Re: POA-2003-502-N, Ship Creek

The National Marine Fisheries Service (NMFS) has reviewed the Port of Anchorage (POA) Response to Public and Agency Comments, dated September 25, 2006, for Phase II of the Port of Anchorage expansion project. The Maritime Administration (MARAD) completed an Environmental Assessment (EA) for the port project on behalf of the POA. The applicant's preferred alternative, open cell sheet pile design (OCSP), would discharge fill material over approximately 135 acres of intertidal and subtidal waters of upper Cook Inlet and dredge 235 acres. Phase I of the project permitted 27 acres of intertidal fill area on the north end of the port. Phase II, if permitted as proposed, would discharge approximately 9.4 million cubic yards of material over the remaining 108 acres of intertidal and subtidal habitat and dredge approximately 633,000 cubic yards of material over approximately 47 acres for the construction of the proposed sheet pile dock. To obtain fill material, an additional 34.5 acres of wetlands would be impacted through the development of the Cherry Hill and North End borrow pits.

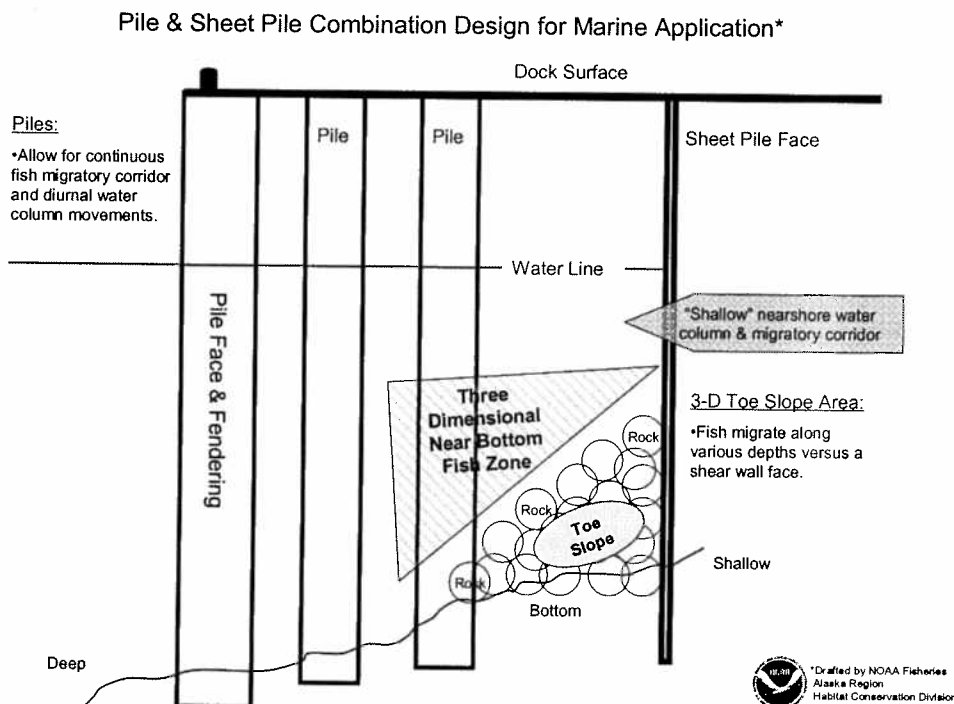
NMFS has consistently recommended pursuing an alternative design for the project that would significantly reduce impacts to living marine resources. Specifically, NMFS has recommended the use of a combination pile support and sheet pile design such as Alternative B in the Environmental Assessment or the Pile-Supported Dock with Slope (see Environmental Assessment page 2-30). Such a design would minimize the loss of nearshore habitat and provide shallow water, contoured slope refuge for out-migrating juvenile salmon and adults. Details on effects of the OCSP alternative on fish and EFH are outlined in our previous letters.

The following figure illustrates conceptually the type of design we would like to see analyzed in more detail. Although NMFS does not have expertise in structural engineering, this concept is based on our experience working on many port and harbor development projects in Alaska that incorporate cost effective design features to minimize impacts to fish habitat.
